Basis of this breakdown

1. Bulletin 3 (M-529 / M-530 / M-531, revision 4, 08/10/2026) was issued after the ductwork in the affected areas had been fabricated and installed per the Addendum 1 drawings. The change therefore includes **disconnecting and removing installed ductwork**, in addition to fabricating and installing the revised work.

Snowflake Fitout - 7 Times Square, Floors 29-31 | COP-SF-05 Bulletin 3 Revision

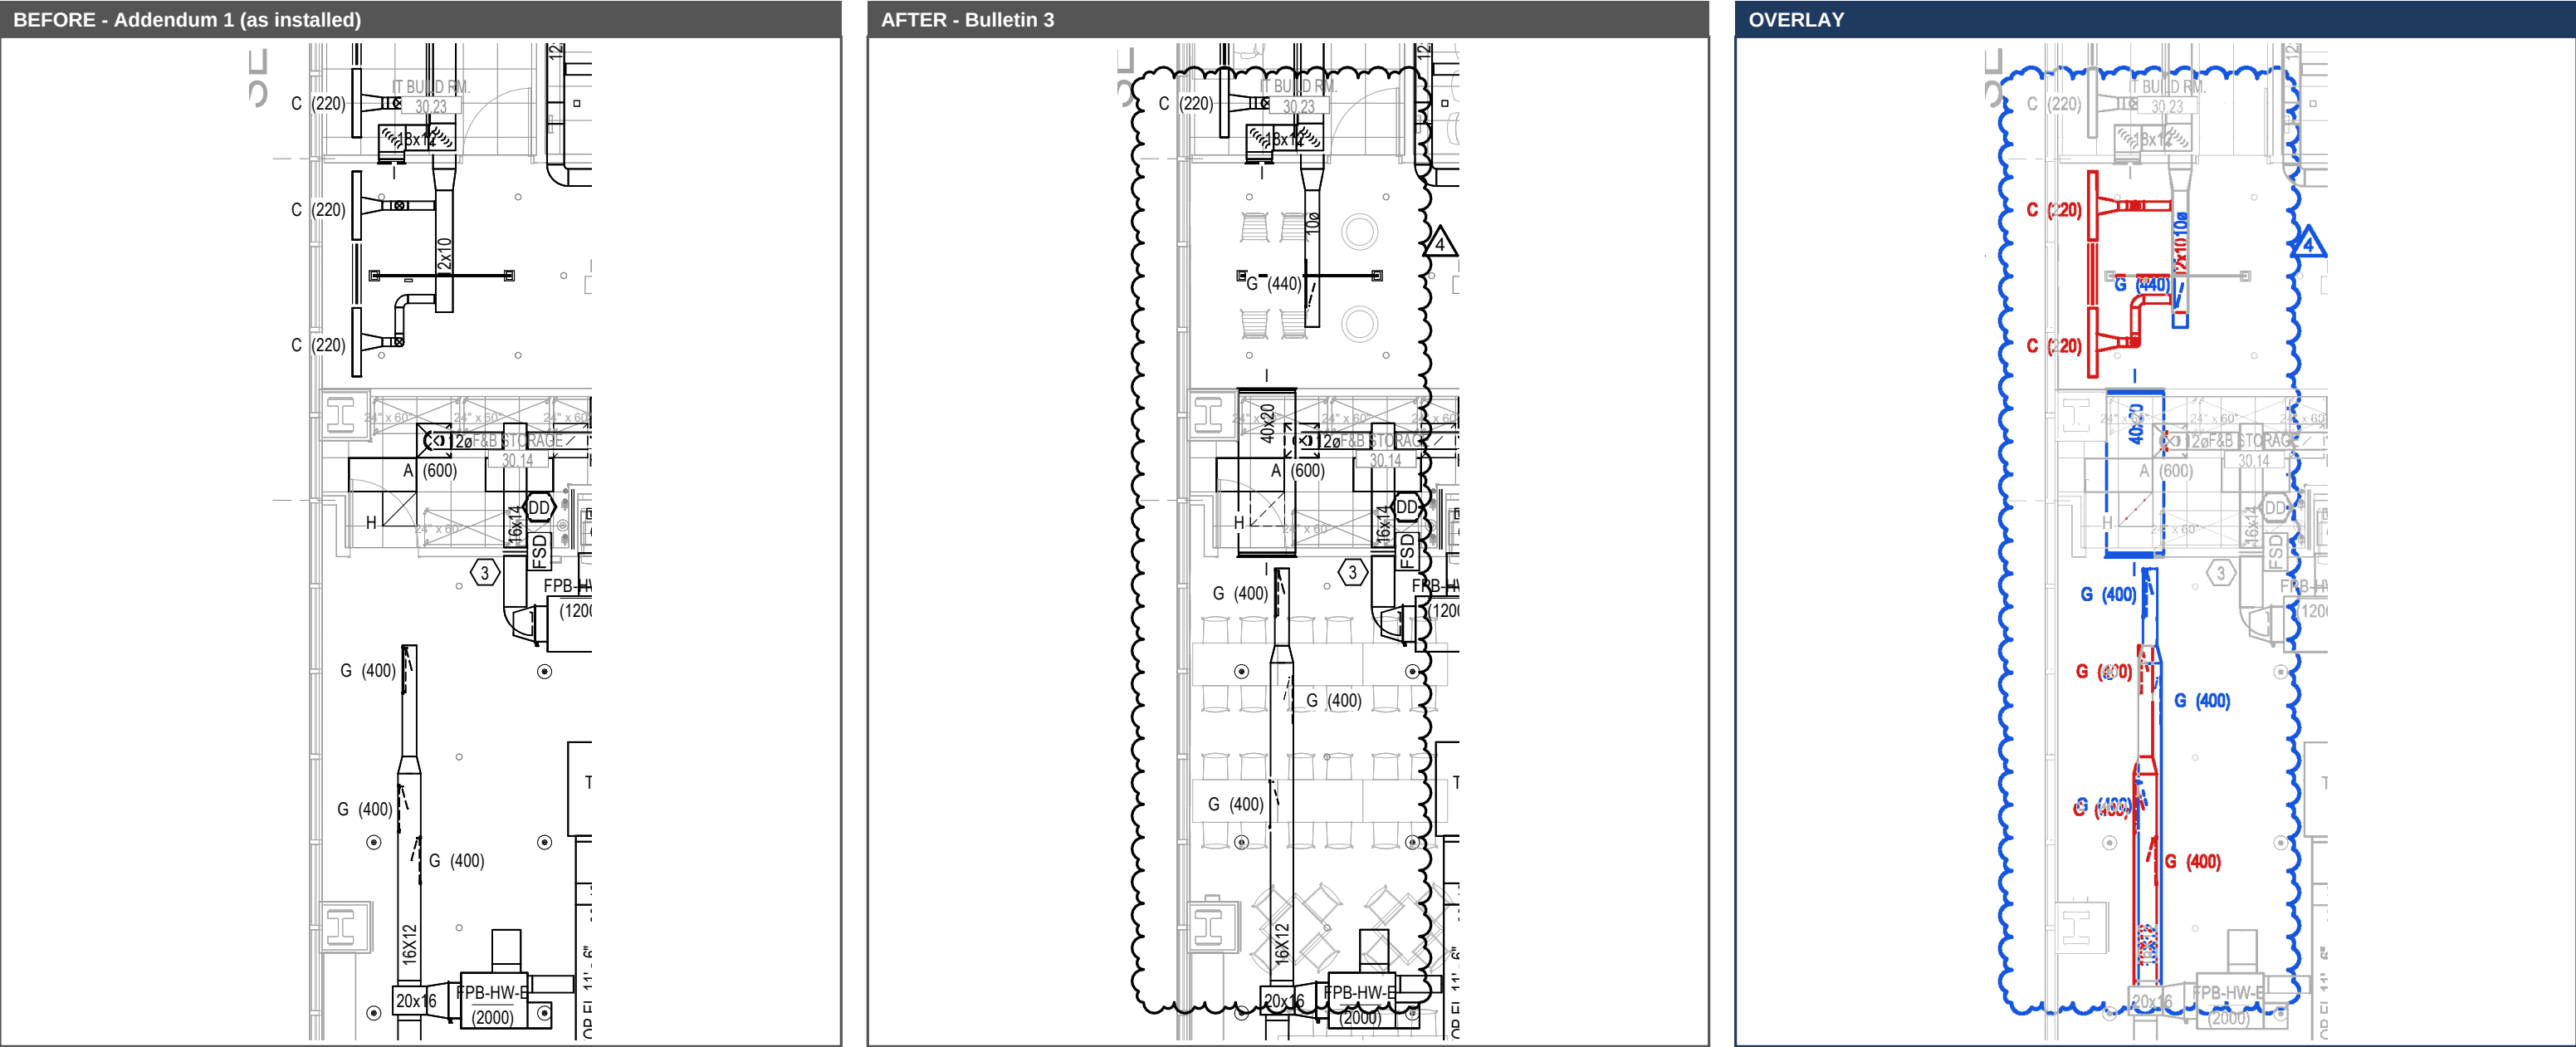
Before (Addendum 1, installed): 12x10 branch with (2) C(220) ceiling diffusers; G(400) linear diffuser run on 16x12 branch.

After (Bulletin 3): 12x10 branch and (2) C(220) deleted, replaced with 10ø branch to (1) new G(440) linear diffuser. New 40x20 transfer duct at F&B Storage 30.14. G(400) linear diffusers relocated along the 16x12 branch.

Work required: Disconnect and remove 12x10 branch and (2) C(220). Install 10ø branch, 40x20 transfer duct, rework 16x12 branch. F&I G(440) linear diffuser with plenum, relocate G(400) diffusers.

Area 30-2 - Lounge 30.02 - new transfer ducts

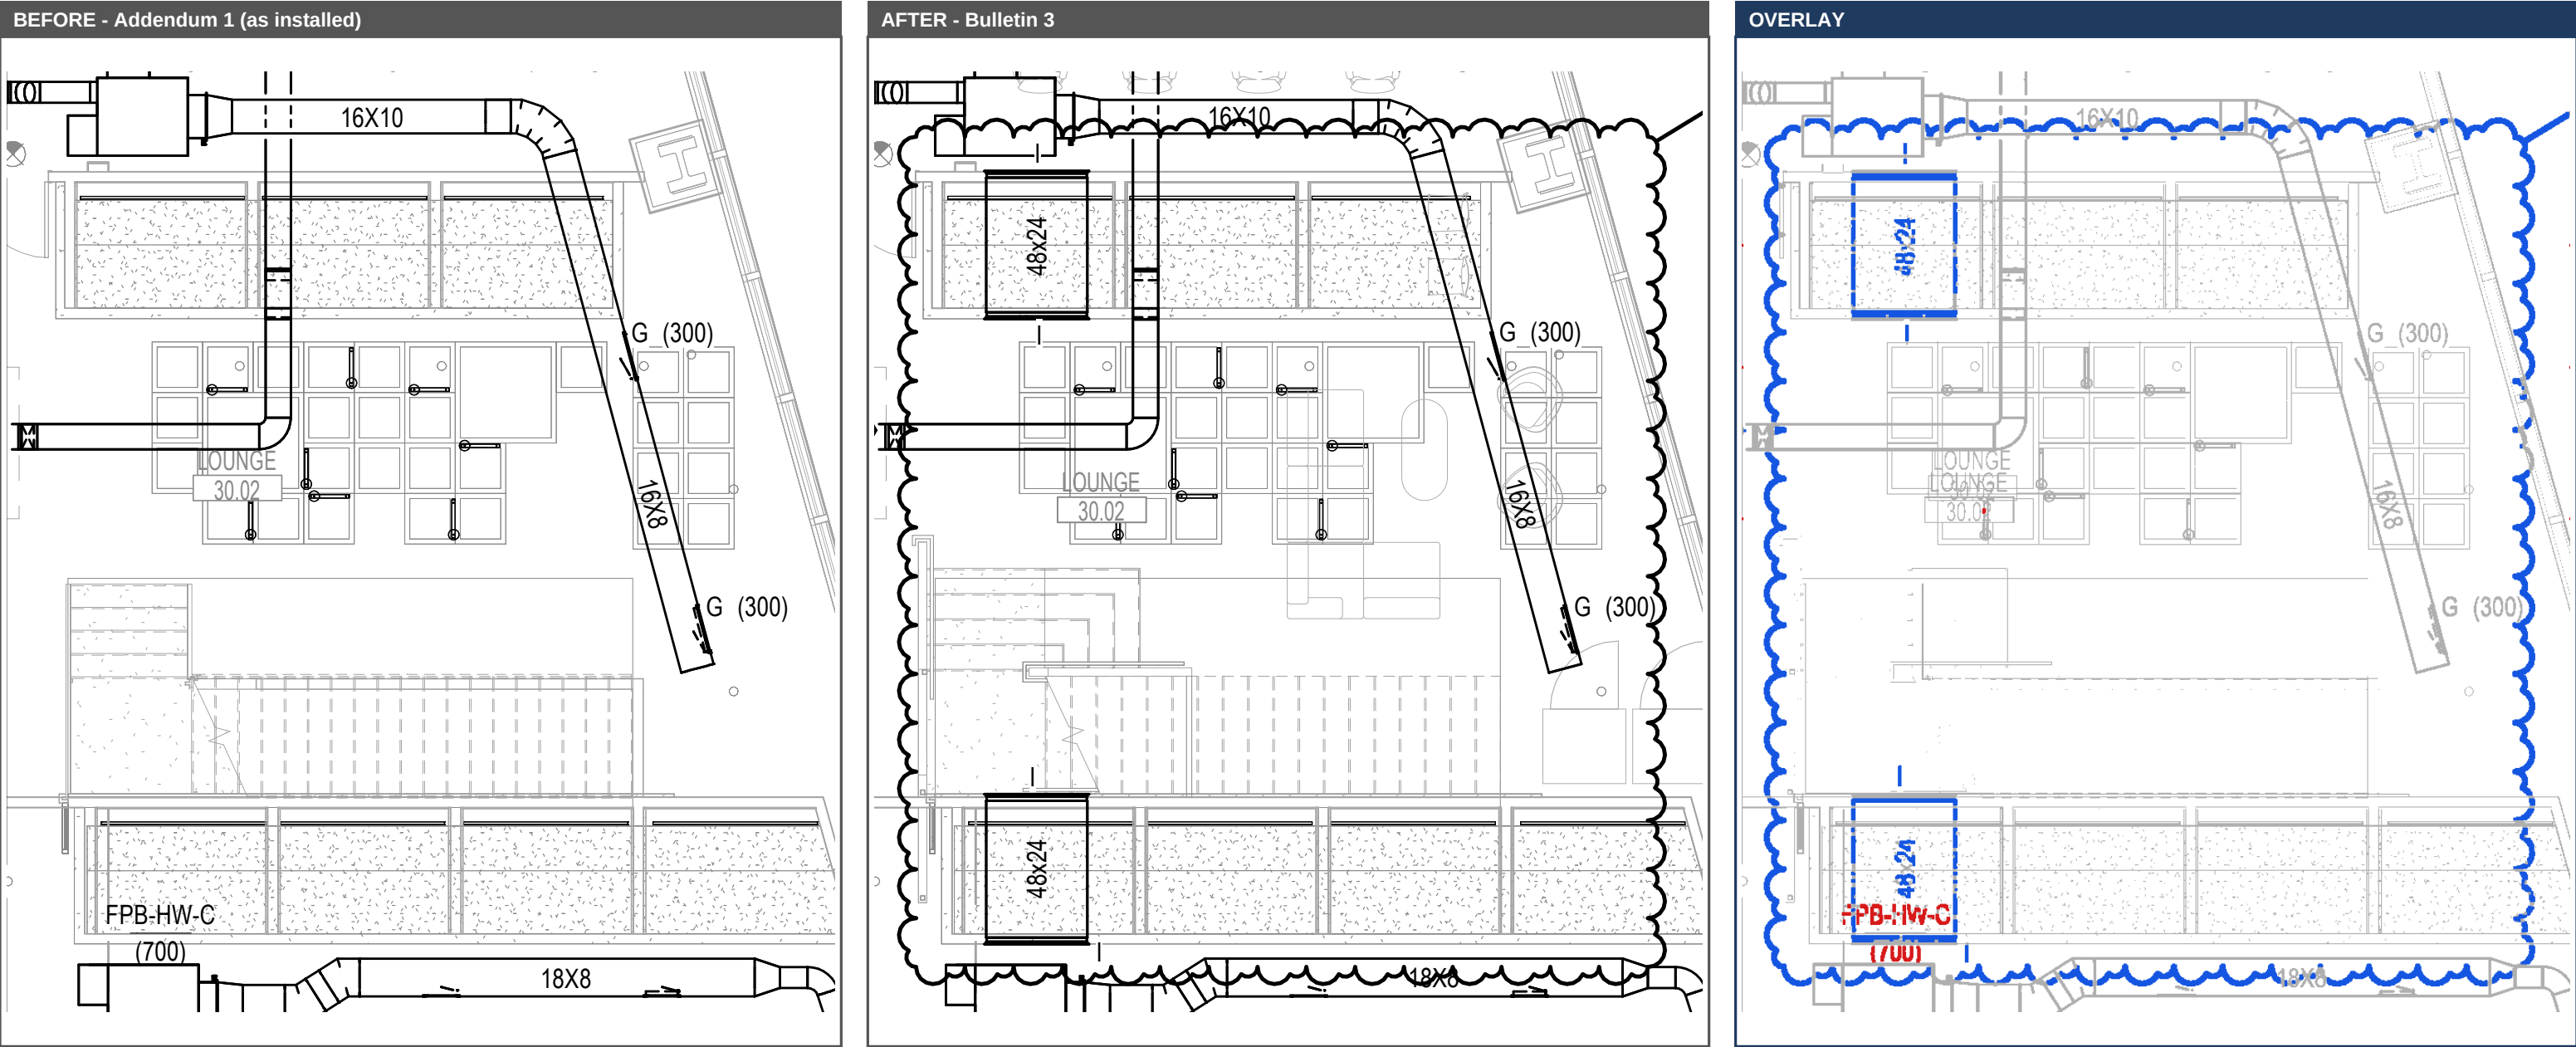
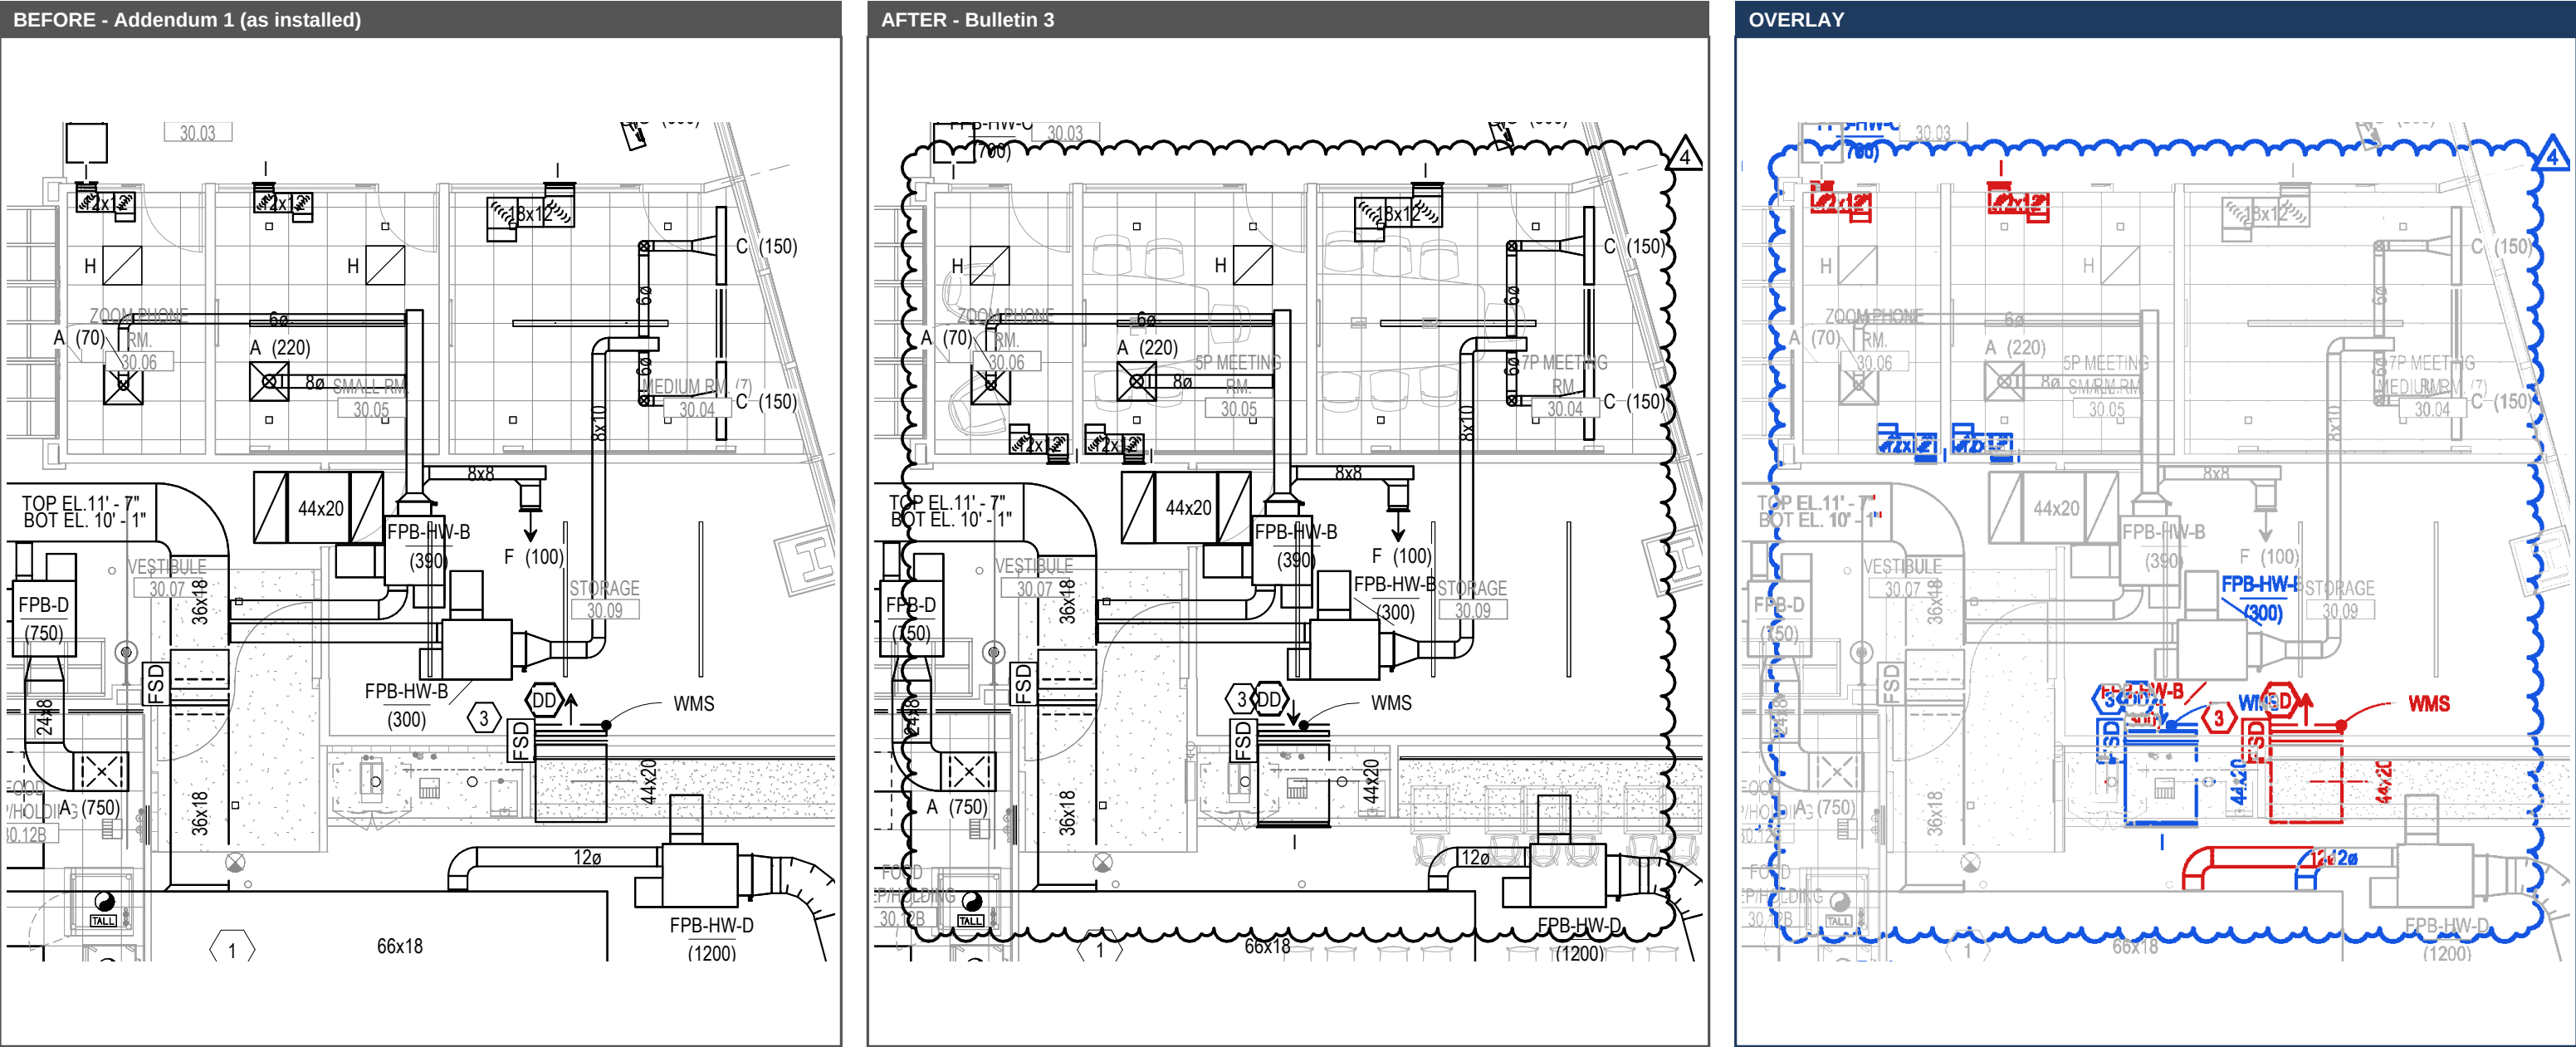
Before (Addendum 1, installed): No transfer ducts at Lounge 30.02 walls.

After (Bulletin 3): (2) new 48x24 transfer ducts.

Work required: Fabricate and install (2) 48x24 lined transfer ducts.
